Access Compliance Report

Public Rights-of-Way

(Pedestrian Signals)

Intersection ID: N/A	Main Street:	Cross Street: N/A	Location: N/A
ADA ID: 804C011BD4D9	Signal Type: Two Push Buttons-Non APS	Overall Compliance: No	Severity Score: BTN 1:N/A BTN 2: N/A No BTN: N/A
Codes/Mitigation Info/Possible Solution		Field Measurements/Component Compliance

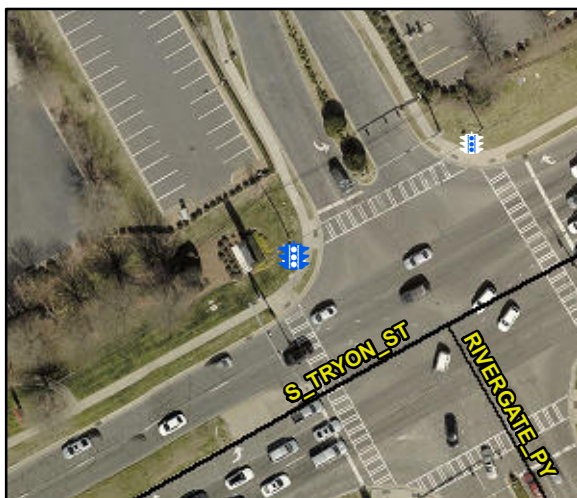
Surveyor Notes: TEXT HT 1/2

PROW/ADA: R410.6, R209.1, TMUTCD 4e.08, R406.2

Possible Solutions: Replace Signal Push Button With APS Button on New Post. Remove & Replace Sign.
